Amendments to the Drawings:

REMARKS

Fig. 3

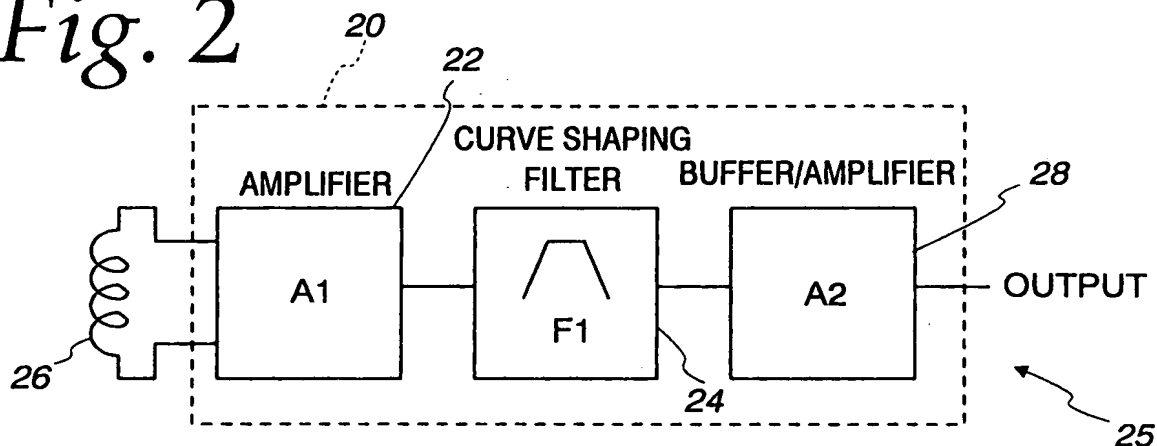
The attached sheets of drawings includes changes to FIG. 3. This sheet, which includes FIGS. 1-3, replaces the original sheet including FIGS. 1-3. In FIG. 3, the AMPLIFIER/PROCESSOR 38a, 38b blocks have been amended to show an amplifier, an analog-to-digital converter, and a processor within the blocks.

Regarding claims 23-24 requiring an analog-to-digital converter, this feature is now shown in amended FIG. 3 as the box labeled “ $\Sigma\Delta$.” No new matter is introduced by this amendment.
